IDAP REPORT

| Property: | 55 Long Street STRATHFIELD DA 2020/138 |
| Proposal: | Demolition of the existing dwelling, construction of a two (2) storey dwelling with basement parking, swimming pool and front boundary fence. |
| RECOMMENDATION OF OFFICER: | REFUSAL |

Figure 3. Basement Plan

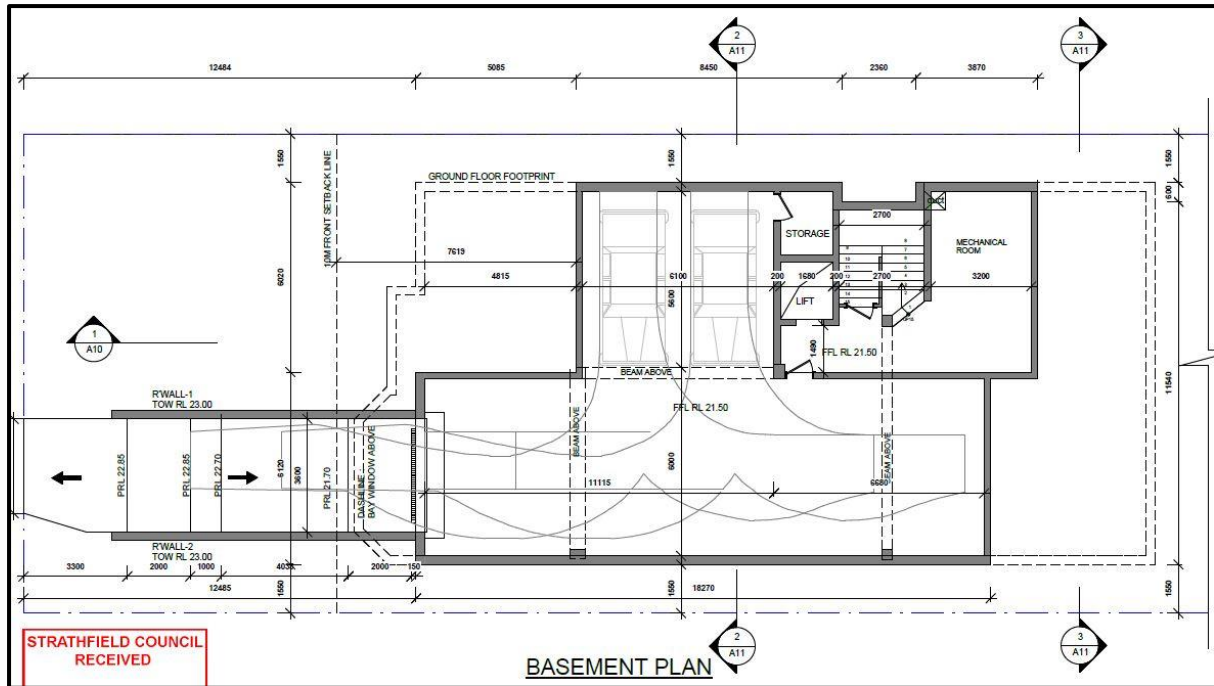
As mentioned above, the proposed development is considered excessive in terms of bulk and scale. It is apparent that the excess bulk and scale are the result of both the contravention to the FSR development standard and poor site response of the design. Of particular note is the manner in which the design responds to the flooding conditions of the site whilst trying to accommodate a basement level and large void spaces. For instance, the finished floor levels are raised significantly higher than the freeboard levels for the site and this is likely due to the required headroom for vehicular access into the basement. The basement level involves a protrusion that is greater than the maximum 1.0m control in the SCDP 2005. The excess height adds to the bulk and scale of the proposal. As highlighted in the SCDP 2005, basements are not encouraged on flood affected sites and the proposal highlights the unresolved matter associated with being able to design a site-responsive building of reasonable bulk and scale, whilst facilitating a basement level, on a flood-affected site. The proposed development fails to reconcile this matter and therefore, the excess basement level protrusion is unacceptable and not supported.

The matter relating to the excess protrusion of the basement level has been discussed in detail above.

9. The proposed development is considered unacceptable pursuant to the provisions of s4.15(1)(a)(iii) of the *Environmental Planning and Assessment Act 1979* as it fails to comply with the control under Clause 8.2.3 (Basement) of Part A of the Strathfield Consolidated Development Control Plan 2005. The proposed basement level comprises a protrusion of more than 1m above ground level.

Figure 4. Ground Floor Plan

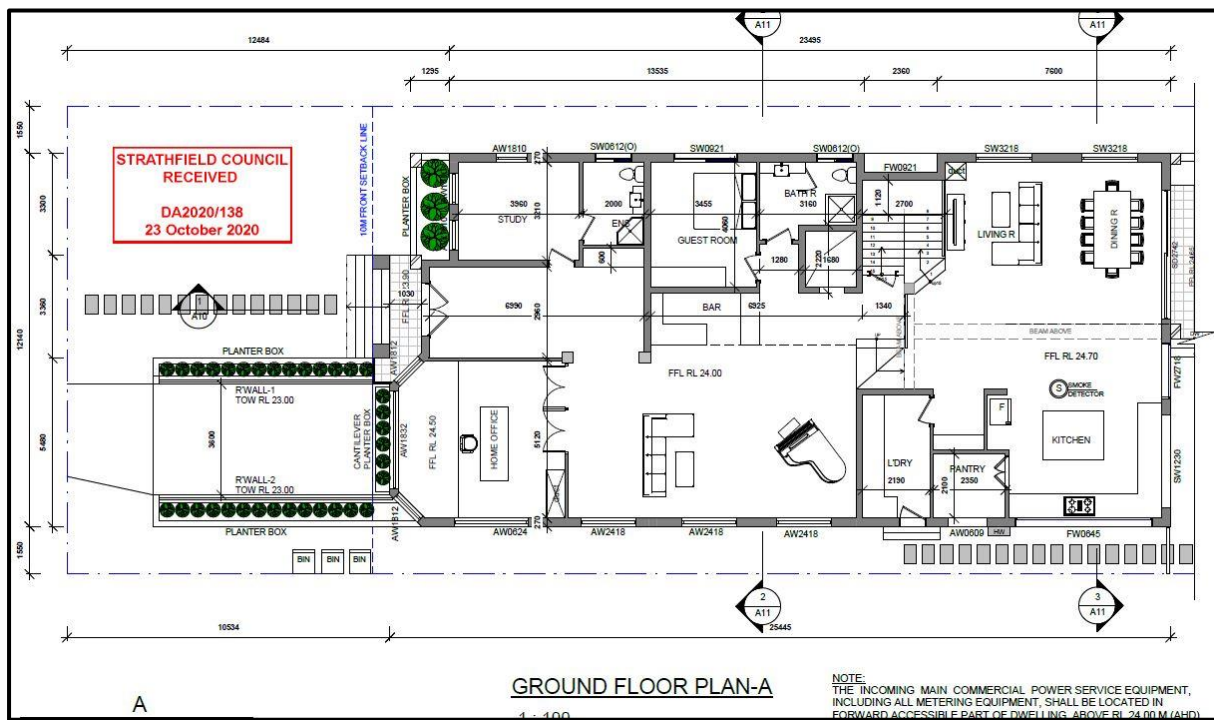
The large void space over the living and dining room is excessive and features a 6m floor to ceiling height. This excess internal wall height is partially due to the void and partially due to the unnecessary splitting of the finished floor levels on the first floor. The size of the void space combined with the excess height creates a highly bulky built form. Thus, the variation to the maximum floor to ceiling height control is not supported.

The east-facing windows in the centralised living space are of concern as the finished floor level is elevated by over 1m above natural ground level. The west-facing windows in the living and dining room may also result in some overlooking. The BBQ area is also elevated by at least 0.5m above natural ground level. If supported, conditions can be incorporated to modify the relevant windows to have obscured glazing to 1.5m and to provide a privacy screen across the western elevation of the BBQ area, to minimise potential privacy impacts from these spaces.
